# UNITED STATES PATENT AND TRADEMARK OFFICE

APPLICATION NO.	FILING DATE	FIRST NAMED INVENTOR	ATTORNEY DOCKET NO.	CONFIRMATION NO.
10/562,399	06/06/2006	Arnulf Krogedal	43315-226893	8479

<b>Office Action Summary</b>	<b>Application No.</b> 10/562,399	<b>Applicant(s)</b> KROGEDAL, ARNULF	
	<b>Examiner</b> MATTHEW A. JOHNSON	<b>Art Unit</b> 3656

## DETAILED ACTION

FIG. 2

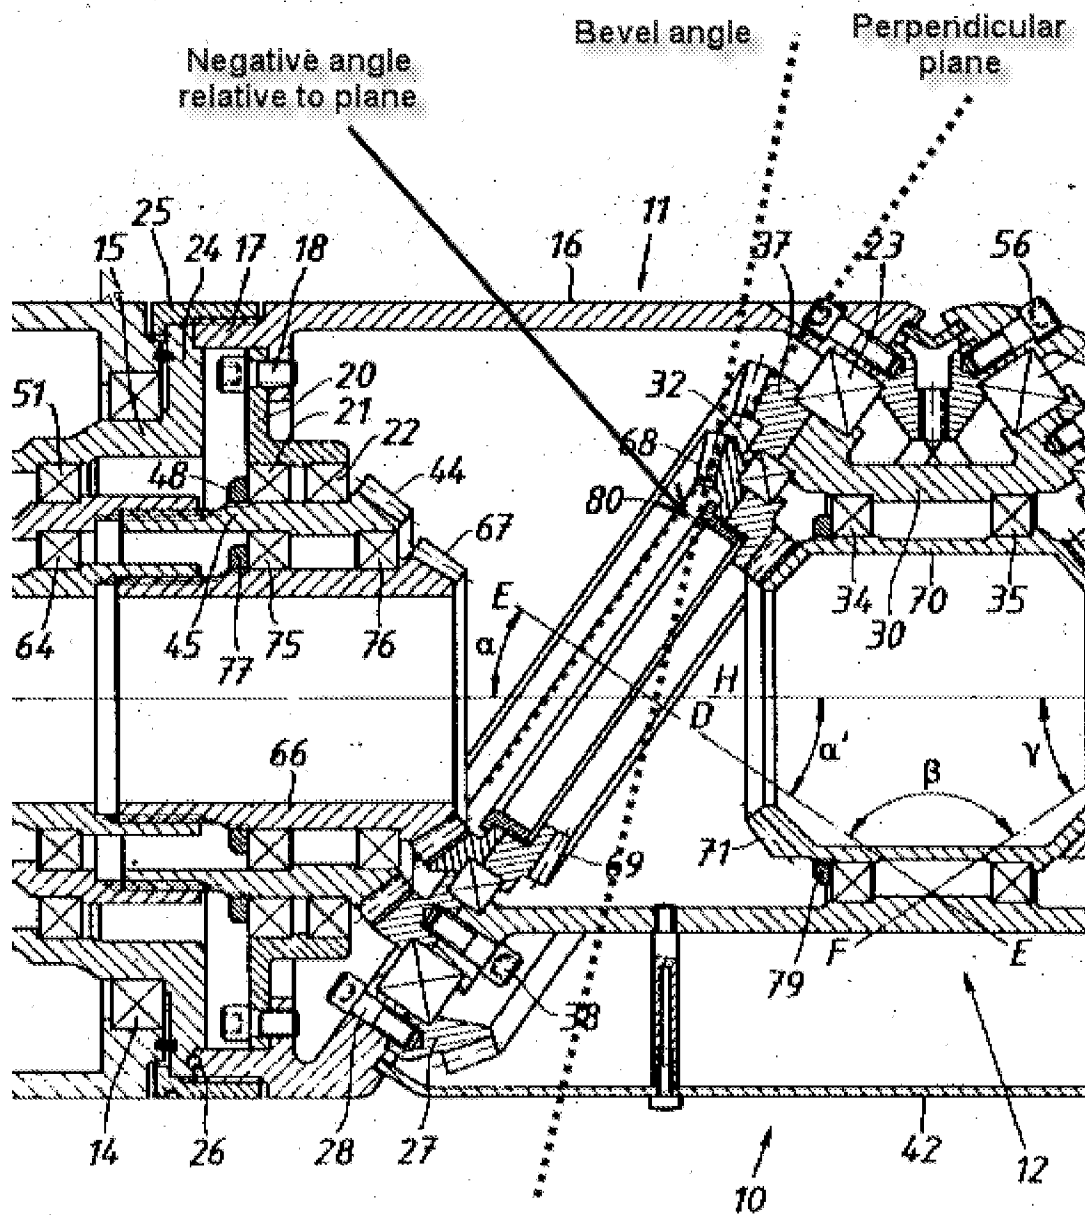
- wherein a generatrix of the conical surface of least one of said gear members (one of gears 68, 37, 74) has a negative bevel angle (as shown in Fig. 2, gears 68, 37 and 74 are concave bevel gears having internally formed teeth that are angled inwardly relative to a plane perpendicular to their rotation axis) relative to a plane perpendicular to an axis of rotation of said gear member (Fig. 2).

Re claim 2: Dahlquist discloses at least one of said gear members (one of gears 67, 27, 55, 60) has a positive bevel angle relative to a plane perpendicular to the rotation axis (Fig. 2) and at least one other said gear member (68, 37, 74) has a concave bevel gear with a negative bevel angle (as shown in Fig. 2, gears 68, 37 and 74 are concave bevel gears having internally formed teeth that are angled inwardly relative to a plane perpendicular to their rotation axis).

12. Applicant argues that Dahlquist does not disclose at least one gear member having a negative bevel angle relative to a plane perpendicular to an axis of rotation of said gear member. Applicant relies on the prior art figure 6b of the instant application, which Applicant claims came from the Dahlquist reference, to support this position. However, Figure 6b labeled prior art by the Applicant, does not match any of the Figures of Dahlquist, and it is unclear where the drawing came from. That which is depicted in prior art Figure 6b is not an accurate illustration of Dahlquist's device. The rejection is based on the Figures actually disclosed by Dahlquist, and not Applicant's representation of the Figures. As clearly shown in annotated Figure 2 reproduced below, Dahlquist discloses a concave bevel gear (37 or 68 or 74) having internal teeth that are angled inward towards the axis of rotation, relative to a plane that is perpendicular to the axis of rotation. Additionally, describing an angle as negative or positive depends on the perspective used to measure the angle. A positive angle from one side of the plane could also be considered to be a negative angle from the other side of the plane.
